RESOLUTION MODIFYING THE GEARY CORRIDOR BUS RAPID TRANSIT LOCALLY PREFERRED ALTERNATIVE TO RELOCATE THE WESTBOUND TRANSITION FROM CENTER-RUNNING TO SIDE-RUNNING BUS-ONLY LANES ONE BLOCK WEST, TO THE BLOCK BETWEEN 27TH AND 28TH AVENUES

Addendum to Environmental Impact Report

Addendum Date: May 19, 2017

Project Title: Geary Corridor Bus Rapid Transit Project

Figure 2. Hybrid Alternative Bus Lane Configuration Change between 26th and 28th Avenues Proposed in the Final EIS

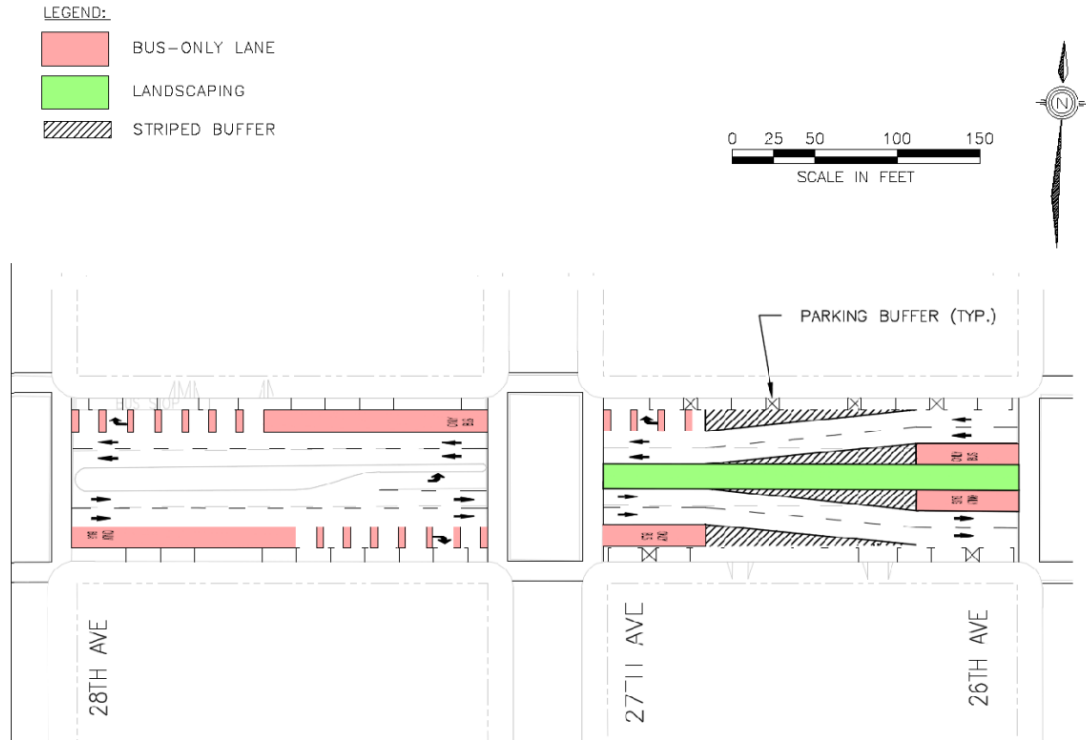
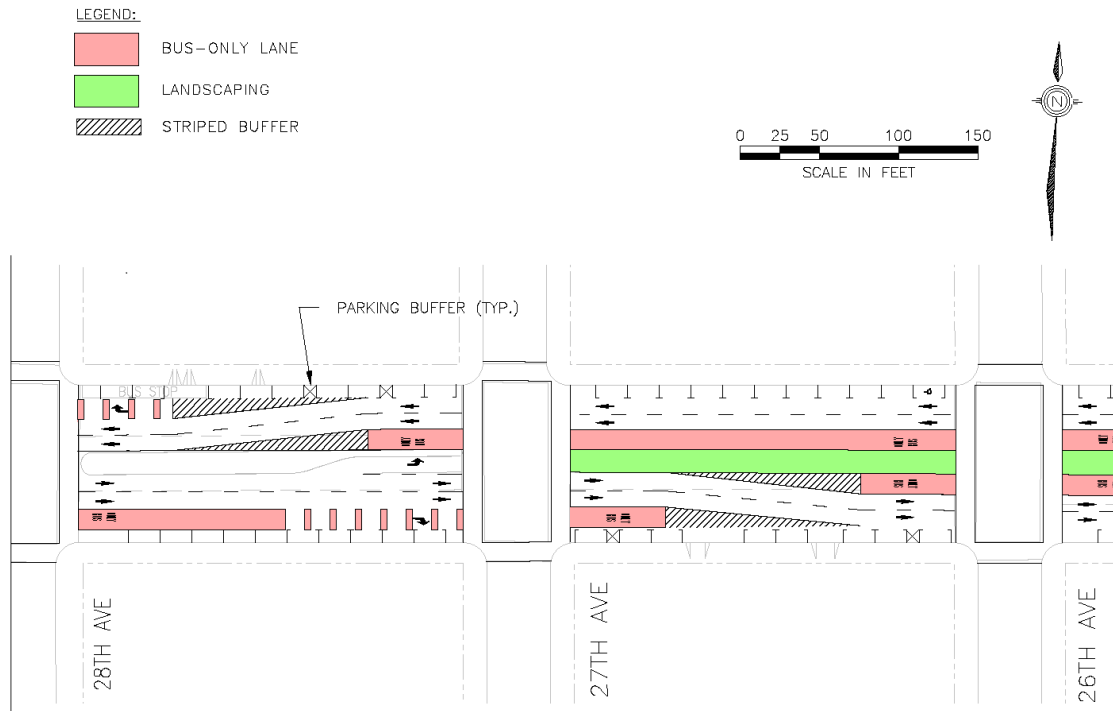
The Project as described in the Draft EIS/EIR and Final EIR assumed a transition from center- to side-running bus lanes in the Outer Richmond neighborhood between 26th and 27th Avenues (see Figure 1). As shown in Figure 1, both eastbound and westbound buses were proposed to transition to or from center/side-running lanes between 26th and 27th Avenues.

As proposed in the Draft EIS/EIR and Final EIR, this design would eliminate nine of the 18 existing angled on-street parking spaces on the north side of Geary between 26th and 27th Avenues due to a combination of the conversion of existing angled spaces to parallel spaces and installation of buffer areas between spaces. On the north side of Geary between 27th and 28th Avenues, the design as proposed in the Draft EIS/EIR would add one parallel parking space to the existing seven parallel parking spaces (eight parallel spaces would result).

The northern side of the block between 26th and 27th Avenues is occupied by the Holy Virgin Cathedral (6210 Geary Boulevard), a religious and community facility. To better accommodate the parking and loading concerns of the facility, the agencies have proposed to modify the transition, as shown below in Figure 2.

As shown in Figure 2, the *westbound* transition would shift one block to the west, to the block between 27th and 28th Avenues. In other words, the center running bus lane would continue for one additional block west. Buses would therefore transition from center running to side running lanes between 27th and 28th Avenues.

No parking buffer areas would be installed on the north side of Geary (immediately adjacent to the Cathedral) between 26th and 27th Avenues, thus preserving two additional parking spaces (retaining 11 of the existing 18 spaces). With this design, the number of parking spaces remaining on the north side of Geary between 27th and 28th Avenues would not change relative to the project as proposed in the Draft EIS/EIR and the Final EIR: a total of eight parallel spaces, an increase of one space over existing conditions.

The *eastbound* transition would remain as proposed in the Draft EIS/EIR and Final EIR, between 26th and 27th Avenues on the south side of Geary Boulevard. No modification to the eastbound transition is proposed.

To achieve the proposed modification depicted in Figure 2, the following changes to roadway striping aspects of the approved project would be necessary.

- Additional red roadway coloring (denoting a bus-only lane) in the westbound innermost (closest to center) lane for approximately one third of Geary between 27th and 28th Avenues.
- Striping of parking buffers on the north side of Geary between 27th and 28th Avenues, instead of between 26th and 27th Avenues as previously proposed, resulting in the provision of two additional parking spaces between 26th and 27th Avenues.

The proposed modification would retain the existing planted median between 27th and 28th Avenues. The proposed modification would not increase the need for excavation or median removal relative to what was disclosed in the Draft EIS/EIR and Final EIR.

In addition to the proposed physical shift in bus-only lanes, the proposed modification shown in Figure 2 would require operational changes to transit signal timing/queue jumps.

Prior to the proposed modification, the westbound transit signal queue jump was to have been located at 26th Avenue; eastbound, the queue jump was to have been at 27th Avenue. With the proposed modification, both transit signal queue jumps would be located at 27th Avenue. Based on analysis conducted by SFMTA, this change in queue jumps would not require any change to pedestrian signal timing at either 26th or 27th Avenues. Indeed, the consolidation of both queue jumps to one intersection would allow for more efficient signal coordination.

Figure 3: Proposed Construction Phasing

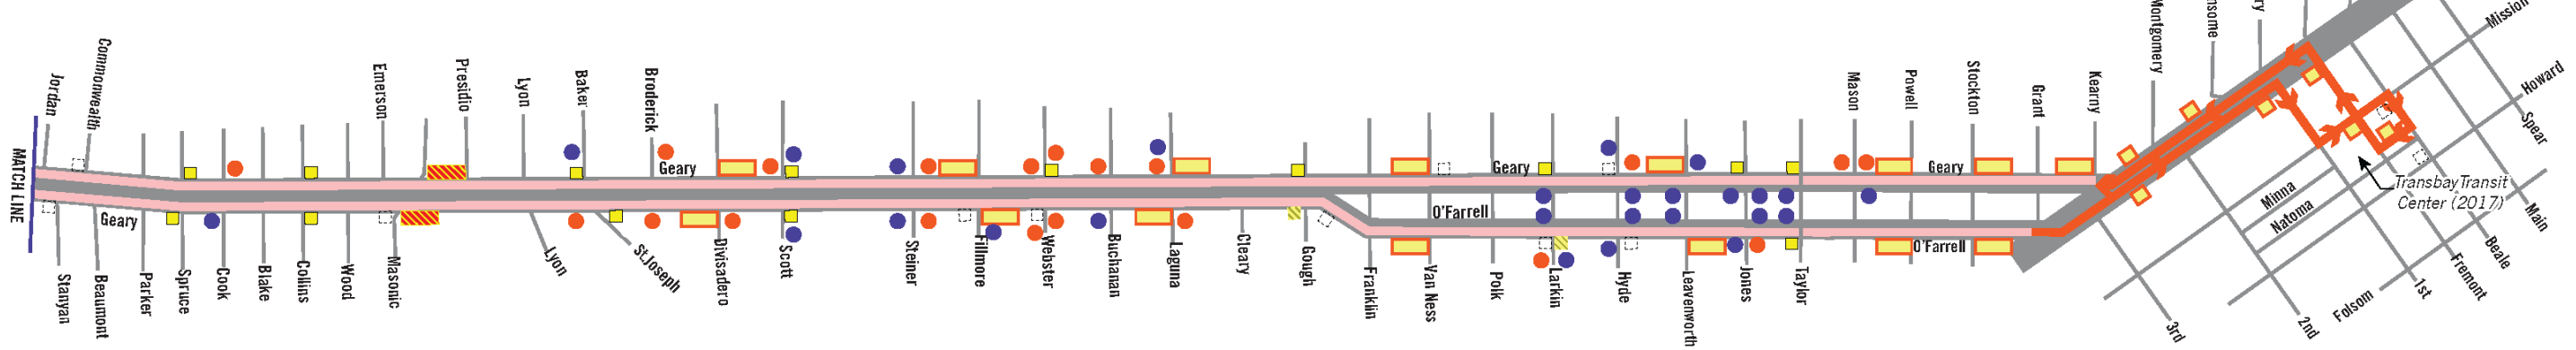
As illustrated in Figure 3 below, Phase I would entail work east of Stanyan Street where BRT would operate in side-running bus-only lanes. Phase II would include work west of Stanyan Street, where BRT operations would be in predominantly center-running bus-only lanes.¹ The project would still be constructed using the Staggered Multiple Block Segment Approach described in Section 4.15 of the Draft EIS/EIR.

The more detailed construction phasing plan that has been developed by SFMTA for the Hybrid Alternative/LPA would still be expected to result in a total construction duration (both active and inactive) of about four years, which is consistent with the higher end of the overall estimate provided in the Draft EIS/EIR.

Phase I and Phase II would *each* be expected to take approximately 100 weeks, including both active and inactive periods and anticipated separate utility work. With more information now available with regard to specific phasing activities and SFMTA's recent experience with similar projects, the duration of construction activities on any given block could take up to 12 months for areas with a larger scope of work inclusive of active and inactive periods, depending on construction scheduling, construction operations, and the extent of the utility work involved. The majority of blocks would have a shorter anticipated construction duration.
